PLANNING & ZONING
COMMUNITY DEVELOPMENT DEPARTMENT
P.O. BOX 2432
ORANGE BEACH, ALABAMA 36561

Orange Beach City Council
Meeting – February 7, 2023

Case No. 1203-PUD-22
Romar Beach Hotel PUD
Preliminary and Final PUD Approval

PUD Master Plan

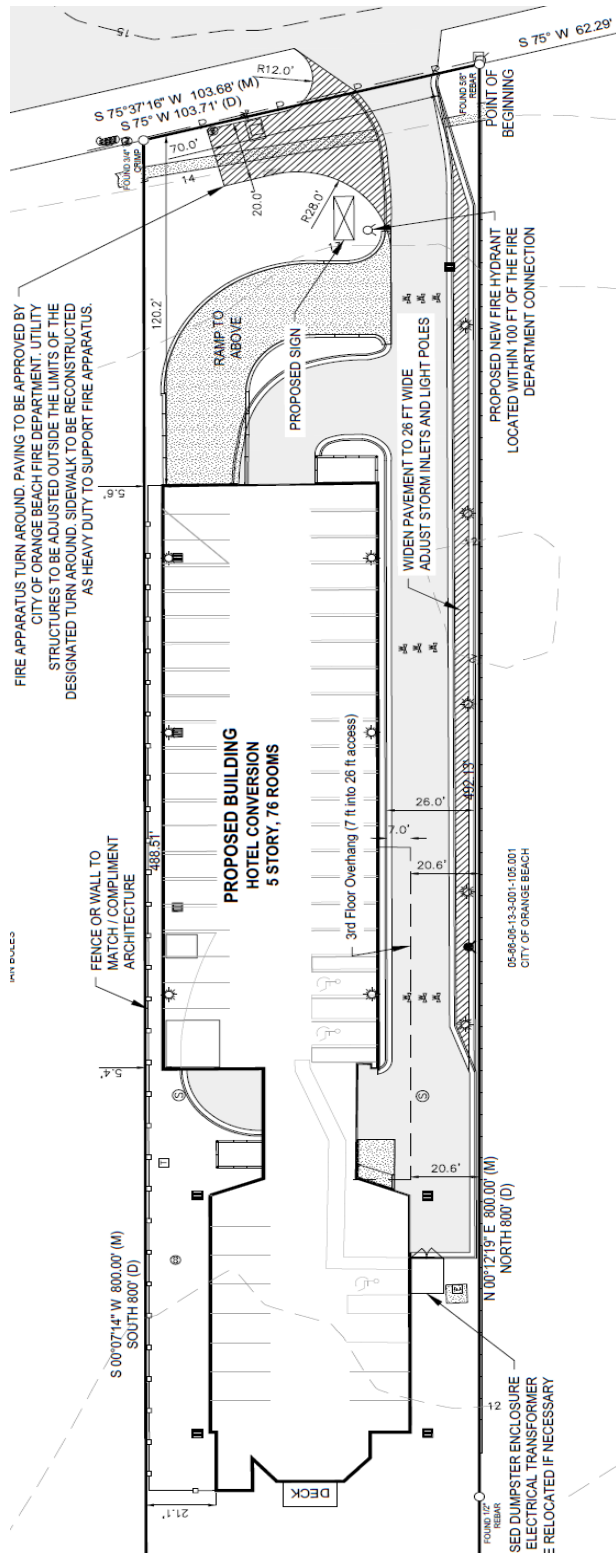
- The third, fourth and fifth floors will cantilever over the driveway on the east side. The cantilevering section will be at least 20 feet from the east lot line.

- The third, fourth and fifth floors of the hotel will cantilever 6 feet over the east driveway leaving 20 feet of open air area for emergency vehicles. The Fire Department has indicated that the east side cantilever presents no issues.

- The landscape plan on this and the previous submission shows landscaping being installed along the west lot line. Since this hotel will not have a pool according to the plans provided, the property owner to the west (Beach Music) has concerns that hotel guests will trespass onto their property to utilize the swimming pools behind the duplexes. Upon staff recommendation, the applicant has amended the site and landscape plans to add an architecturally compatible fence or wall to the west side of the parking structure and existing building to provide a buffer between the hotel and Beach Music.

- In the landscape area between the parking structure and Perdido Beach Boulevard, this PUD proposes an emergency vehicle turnaround area. The Fire Department will need to approve the paving to ensure that it can support the weight of the fire vehicles. With regard to the existing pedestrian-oriented area (POA) sidewalk, the project engineer proposes to keep the sidewalk straight to be consistent and connected with the sidewalks on the neighboring properties. The sidewalk will be reconstructed with heavy duty concrete to support the weight of the emergency vehicles.

1. Planning Commission and City Council approvals of the following deviations to the zoning ordinance.
 - Section 4.03, Minimum Setbacks: Eliminating the required landscape area of 5 feet on the east side between the east driveway and east lot line to accommodate the increase in the width of the east driveway to 26 feet.
 - Section 4.05, Buffering Between Uses: Allowing the new construction areas on the third, fourth, fifth and rooftop levels to have a setback of 20 feet instead of 30 feet from the west side lot line to match the setback of the existing building.
2. Coastal Permits will be required for this project.
